AGENDA
MANDAN PLANNING & ZONING COMMISSION
COMMISSION ROOM 5:15 P.M.
SEPTEMBER 28, 2015

Mandan Planning and Zoning Commission Agenda Item
For Meeting on September 28, 2015
Mandan Engineering and Planning Office Report

Heart Ridge Cove Addition

HEART RIDGE COVE ADDITION

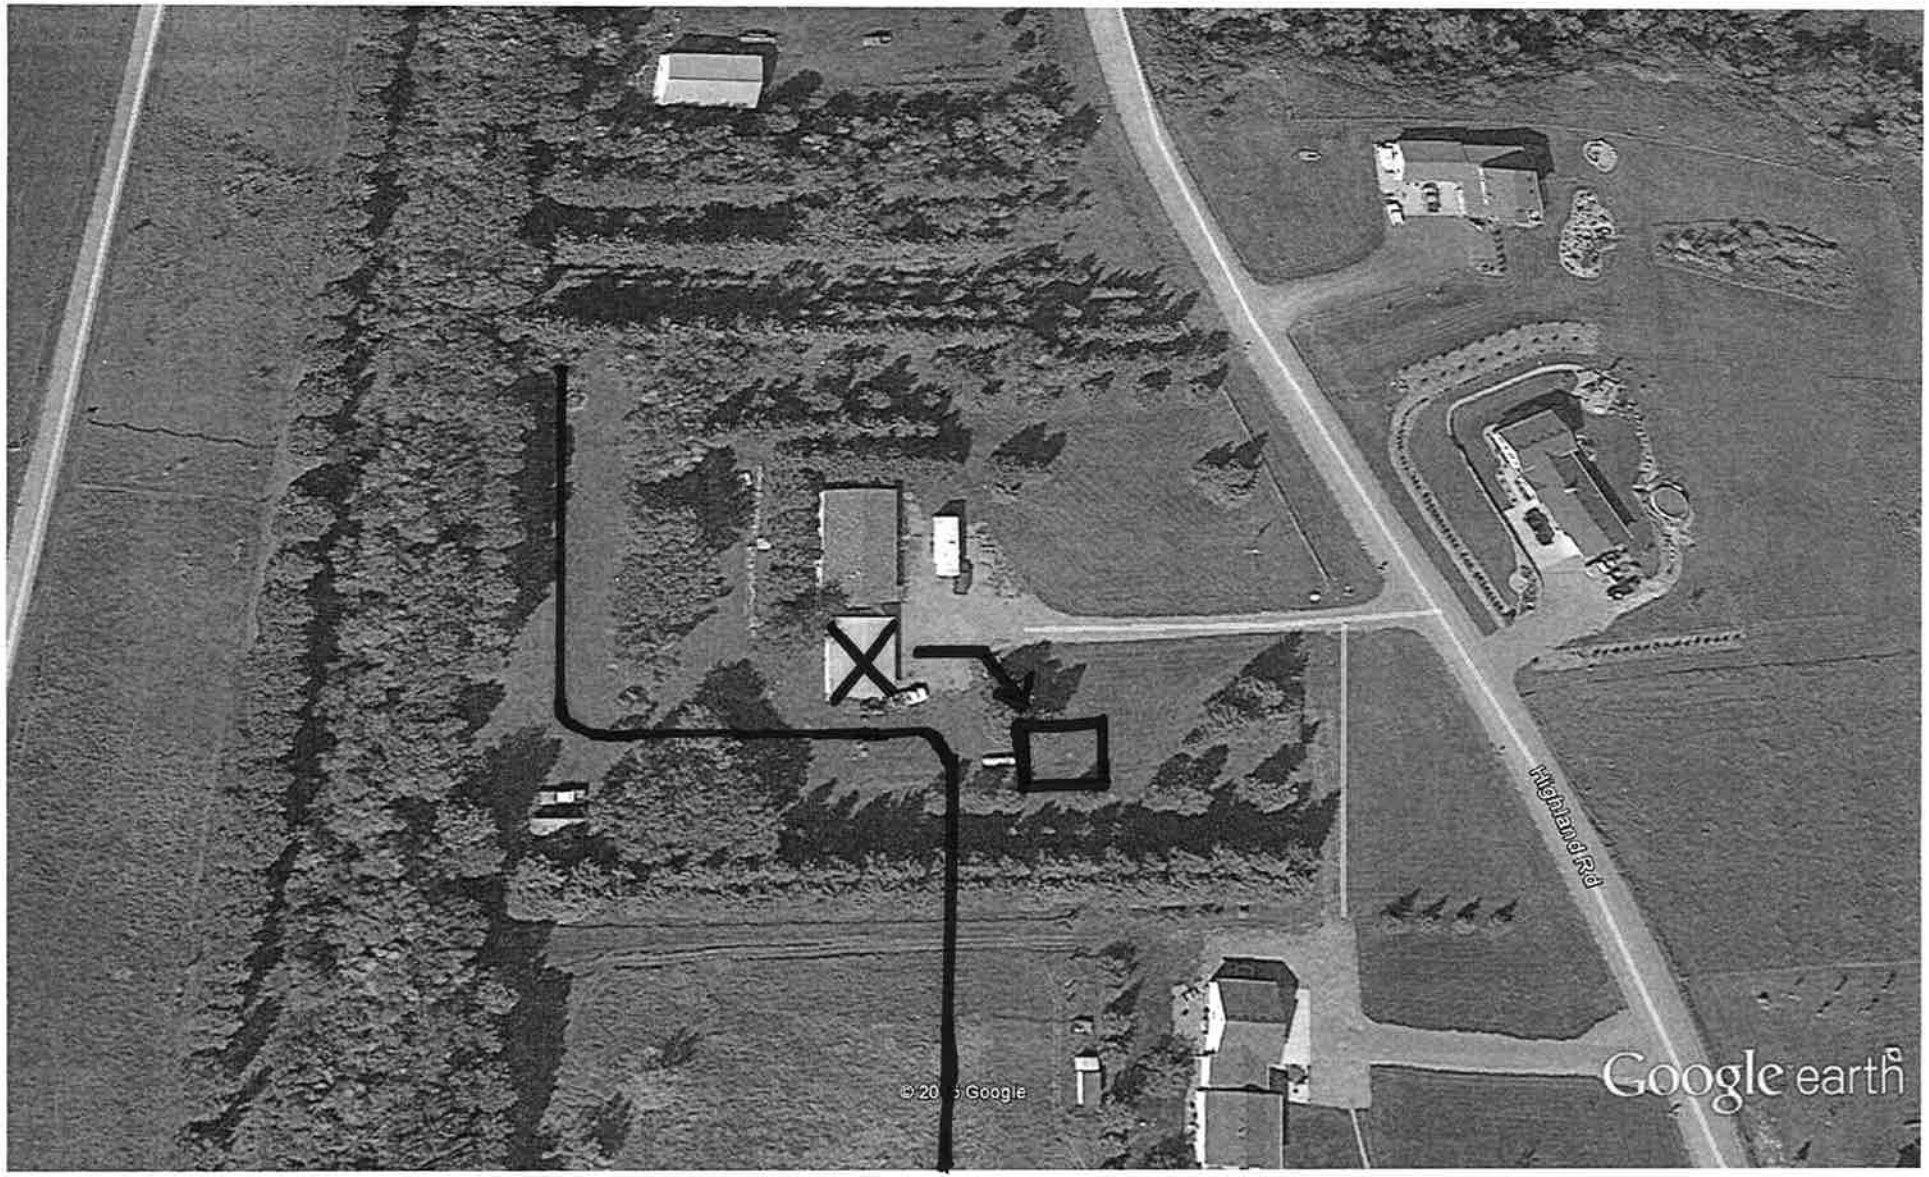
The request is to allow relocation of the existing detached garage to a location in front of the primary structure so that a new attached garage can be built onto the primary structure.

21-03-05 subsection 5 requires that all accessory buildings be located in the rear yard.

a. The primary structure was placed well back from the road in the center of an over 4 acre parcel.
b. Neighboring lots have structures closer to the road than the proposed garage would be.
c. There is a new rerouted power line in the area to the side of the primary structure where this garage would normally be located.
d. The area to the side of the primary structure is a low, wet area.

I am seeking to place my present detached garage near South shelter belt, East of the 7.2 KV electric line.

I request a variance, as placement of this building should be year-round. To place it within the detached garage guidelines, (behind the front face of home) would place it on top of 7.2 KV primary line, or near the lowest/wettest part of backyard. 21-09-16

Staff recommends approval of this variance request

Move to recommend that the city commission approve a variance to allow placement of an accessory building garage in front of the primary structure on Lot 1, Block 1, Patience Subdivision

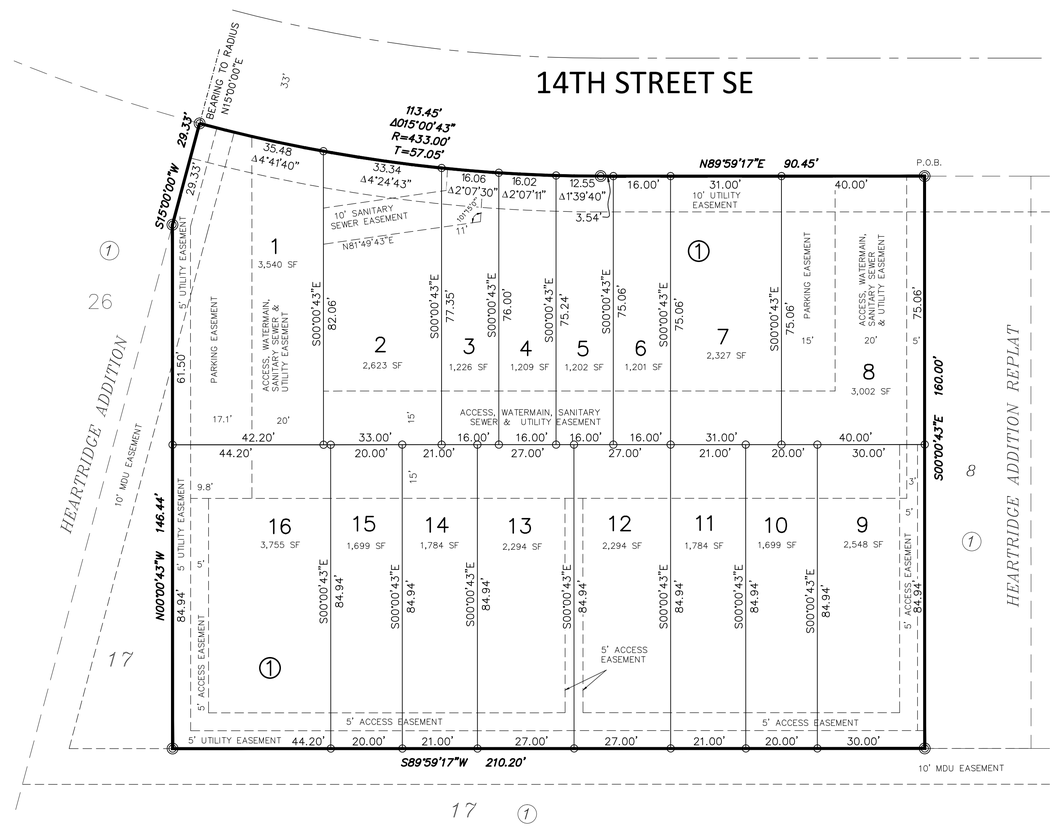
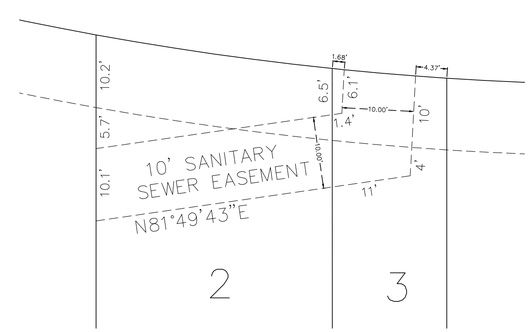
RM lists a minimum lot width of 40 feet. However, later in the text there are adjustments allowed for attached units with no side yards. The existing four-plex units to the east are on lots that vary in width from 21.5 feet to 31.5 feet. The proposed project will have narrow lots.

RM has a floor area ratio of 120% for multi-story structures. Since garages and other unheated storage areas are not counted, only 2 stories of each unit would be counted. That results in an FAR of approximately 64%, about half the maximum allowable.

RM has a 40% ground coverage requirement. 2 of the proposed lots will be commonly owned with driveways and parking areas, but no structures. While individual lots may exceed the 40% standard, the total structure ground coverage for the project is 32%. Adding the 9 proposed parking spaces as specified in the requirements brings the total ground coverage to 37%.

RM has a 15 foot front yard setback. Due to a jog in the front wall of the units, less than half of the frontage of 4 of the 6 front units will be close to the minimum setback. The remaining 2 front units will have a front

RM has a minimum side yard setback of 4 feet for lots less than 50 feet in width. These lots will be less than 50 feet in width. The project is designed with parking areas along the sides so the front row of units will be set back approximately 50 feet from the adjoining properties. The rear units will have between a 10 foot and 20 foot side yard setback. There is an undevelopable wedge of land on the west side between this project and the neighboring single family lot that effectively increases the setback on the west side for the rear units to more than 50 feet.

The code requires a minimum of 2 parking spaces per dwelling unit. Each unit will have a 2 stall garage. The code adds another condition that requires that half the minimum required spaces be exterior with the assumption that people will fill the garage with stuff. All units have a designated storage area in addition to the 2 stall garage. The proposed site plan shows 9 exterior spaces with the possibility of adding one more. This would be 4 or 5 short of the 14 required. As with many recent projects, the adjoining four-plex units have a driveway apron for most of the frontage so there is no on-street parking in front of those units. This project will have space for up to 7 cars to park along the curb between the two driveway entrances.

Create a PUD district with the following requirements and adjustments to RM standards:

1. The minimum lot width shall be less than 40 feet.
2. The maximum ground coverage for individual lots may be greater than 40% with the overall project ground coverage limited to 40%.
3. The maximum building height shall be limited to 3 stories.
4. Minimum lot sizes may be less than 2400 square feet with the overall project average lot size being

5. On-street parking in front of the property may be counted when computing the minimum required parking for the project.
6. The private driveways shall meet the requirements of the fire department.
7. The private driveways shall include an unrestricted utility and access easement.
8. The private driveway parcels 1 and 8 shall be owned in undivided interest by parcels 2-7 and 9-16.
9. The drivable area between structures where the garage doors are located shall be a minimum of 30 feet wide.
10. The public sidewalk along the frontage of the lots shall be constructed prior to issuance of the first occupancy permit.
